MARIN COUNTY COMMUNITY DEVELOPMENT AGENCY

DIPSEA RANCH LAND DIVISION PROJECT INITIAL STUDY/DRAFT MITIGATED NEGATIVE DECLARATION

COMMENTS ON THE INITIAL STUDY AND RESPONSES TO COMMENTS

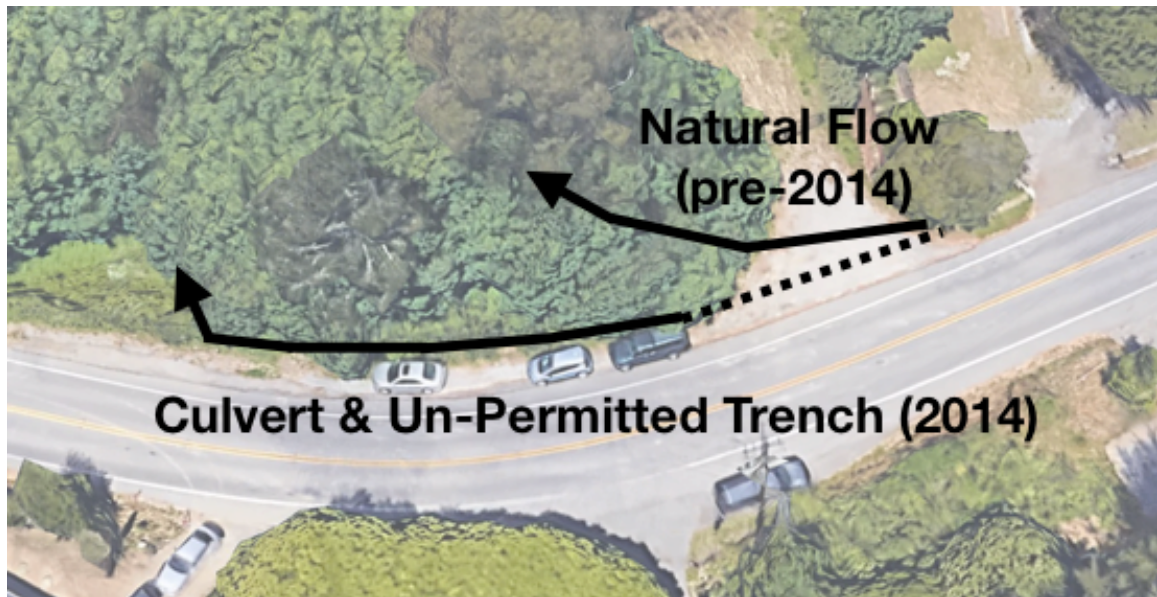
A. Intermittent Stream – The stream located directly south of the “*Non-Permitted 2014 Road*” (see Figure 4-1) has been incorrectly identified as an “Ephemeral Stream” both in the environmental studies and on the applicant’s subdivision application. This is an Intermittent Stream (i.e. has running water intermittently throughout the year) and as such should be protected by the County’s Stream Protection Ordinance. There are several indications this creek is Intermittent (and not Ephemeral):

- a) The United States Geological Society mapped these as Intermittent Creek (as shown on the applicant’s Figure 4-1)
- b) In 2018, water was documented running down this ravine in April after seven days of no precipitation (emailed to Planning Department Jocelyn Drake)
- c) The steep ravines in Zone 4 of Rice’s mapping of the area are an indication of active creeks and/or springs.
- d) The wetlands identified on Figure 4-1 are fed by naturally occurring springs which feed the Intermittent Creek.

I see no reason why the “*Non-Permitted 2014 Road*” should be removed and possibly cause additional environmental damage. However, in lieu of removing the “*Non-Permitted 2014 Road*” constructed road, I would like to see assurances in the form of mitigation measures (covenants recorded on the subdivision map) that this environmentally critical area is left undisturbed, no material can be removed or disturbed,

and nothing can be added in the future to this area. This *“Non-Permitted 2014 Road”* should only be used for emergency personnel and never be used as a location for ingress/egress from the property as that could cause additional environmental impacts to the Redwood Creek watershed.

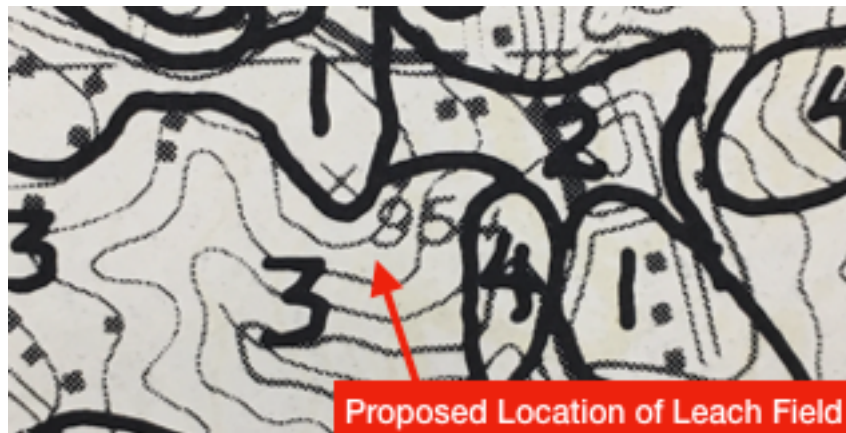
- C. Drainage Ditch along Panoramic Highway** – As part of the *“Non-Permitted 2014 Road”* construction, the applicant constructed an approximate 120’ long drainage ditch along the fence line on Panoramic Highway to redirect the flow of water away from the wetlands area and further down the property. This unpermitted ditch has affected the natural flow of storm water and should be considered as part of the applicant’s environmental application. The poor maintenance of this ditch has contributed to run off washing away dirt and causing erosion of the embankment.

The only acceptable way to mitigate this alternation is to fill the drainage ditch and restore the natural flow onto the applicant's property immediately below the "Non-Permitted 2014 Road" into the riparian wetlands. This will require removing and realigning the culvert pipe to property directly the water away from the drainage ditch and onto the applicant's property. (See image below).

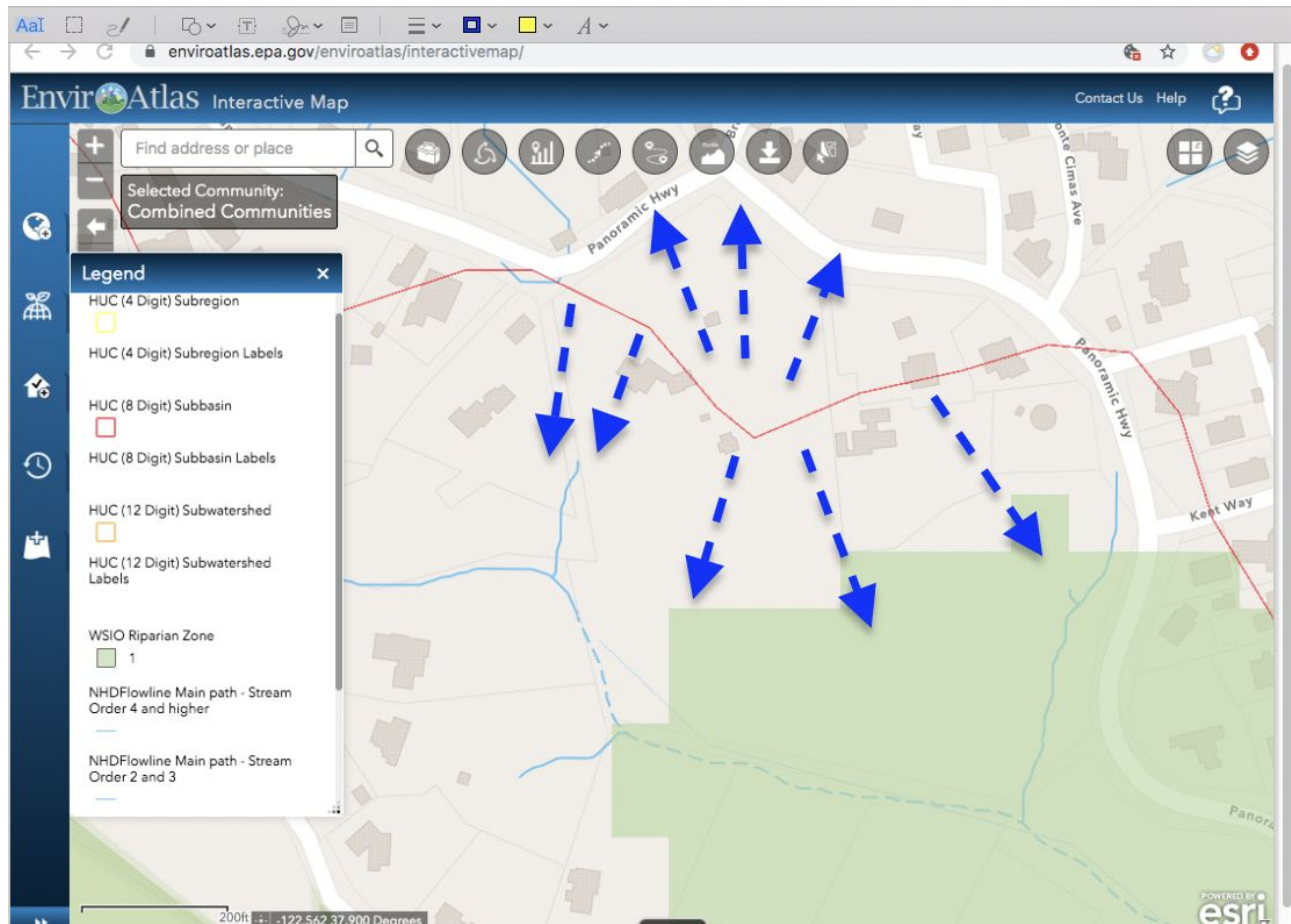
Figure 4.1 (from MND augmented to reflect septic fields in orange and does not include two more on North Corner and on Neighbors property just above orange straight line).

Overlay of issues on Figure 4.1 - Neighbors septic system setback was built in the SCA and their pipes may cross the creek. The streams, because they are blue line, are all intermittent (seasonal) or perennial because they flow most of the year. We have plenty of evidence for that. On the map there is a missing tributary near the main house (existing).

- W-74 The augmented version of Initial Study Figure 4-1 referred to in this comment is included in this comment letter and designated comment W-49 (it also appears in comment Q-99). The location of septic systems associated with adjacent properties, including those located on the Project site and operated or maintained through an easement, are an existing condition, not part of the Project. Changes to these septic systems are not proposed as part of the Project and, as such, impacts are not evaluated in the Initial Study regarding the location or use of existing septic systems. Regarding potential impacts from proposed septic

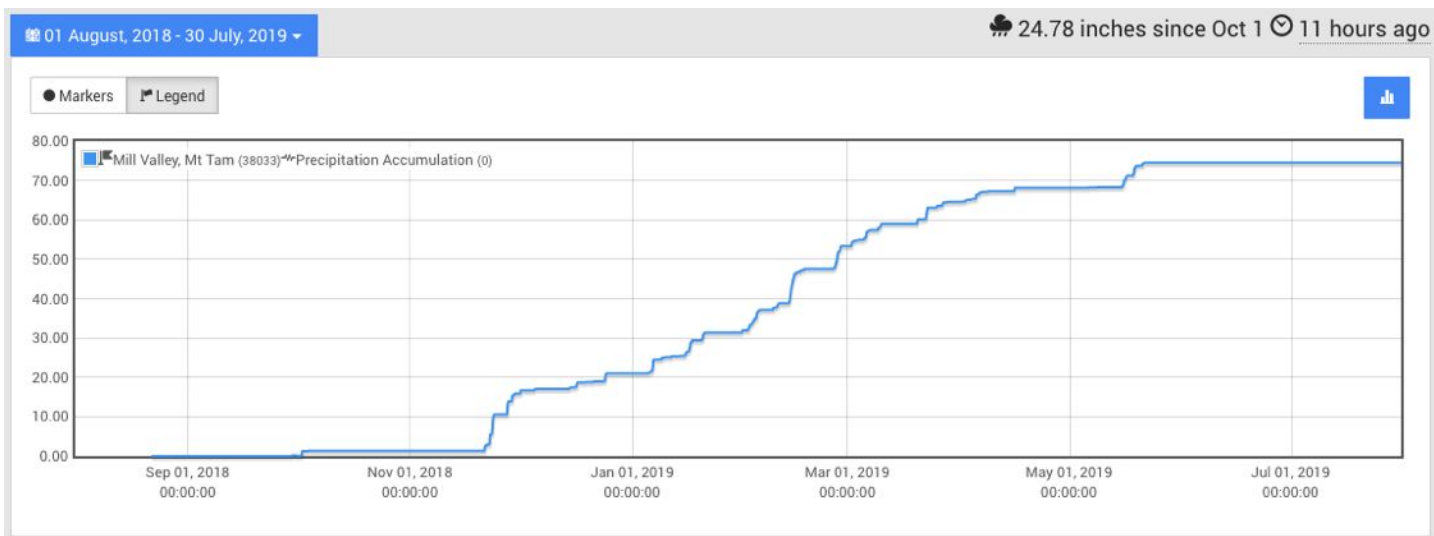
The project’s community of Muir Woods Park received 75 inches of rain in 2018-2019 season and 90 inches of rain in 2017-2018 Season

2018-2019 Rain Totals from Mt. Tam State Park. One Rain Marin County

The estimates by the hydrology report of 26”-36” per year is dangerously inaccurate and any design of any septic or stormwater systems – at these levels will put neighbors and downstream Redwood Creek at risk. Designing a system that is based on 100 year event that isn’t every hundred years because the numbers are off. Rainfall totals have exceeded three times the specified amounts on Page 35 of the MIND.
